## Re: Review Questions

I really don't know what more I can do to help you - I have specifically redlined everything I know will be an issue to the Board. Here are the redlined drawings again.....

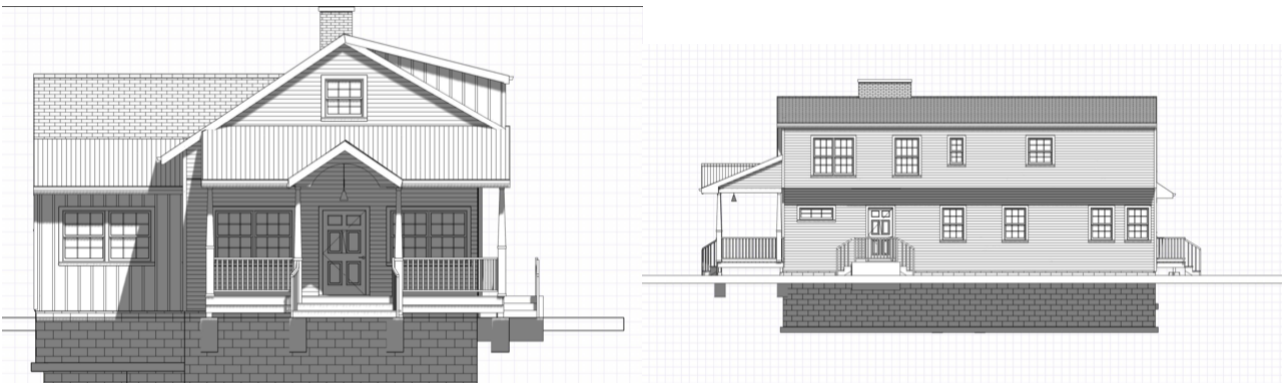
They are definitely better - which is something I have already shared - but there are still a lot of details that are strange and not worked out - the column bases are still floating off the porch, columns are weirdly proportioned, the railing in back don't connect, the steps in the back are disconnected from the new stoop - are they the same unit? wood? concrete? Just so many details that the Board will ask about and I am certain it will get tabled to work on these details. I am allowing this to come to the Board but want to be realistic about what you should expect. I am really at a loss how else to point out all of these details without doing them myself which I cannot. Below is an example of how we need to see details... I believe I sent you some example drawings already too and you can access our past applications to look at other applicants successful drawings on the city's website under documents/agendas and meetings....
